UNITED STATES PATENT AND TRADEMARK OFFICE

APPLICATION NO.	FILING DATE	FIRST NAMED INVENTOR	ATTORNEY DOCKET NO.	CONFIRMATION NO.
10/688,366	10/16/2003	Mathias Krauss	KN-66	2291

Office Action Summary

DETAILED ACTION

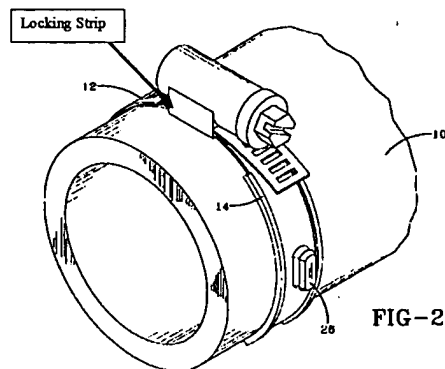
In regards to claim 1, Chatterton discloses a connection of a hose clamp (12) and a hose (10) that is provided with projections, wherein the hose clamp surrounding the hose is pre-positioned between the projections before tightening the hose clamp on the hose, the improvement comprising:

the projections (32) being arranged on opposed sides of the hose clamp and having gaps;

a locking strip having laterally projecting tabs and fastened on an inner side of the hose clamp (see Figure 2 below);

wherein the laterally projecting tabs engage in positive-looking way the gaps.
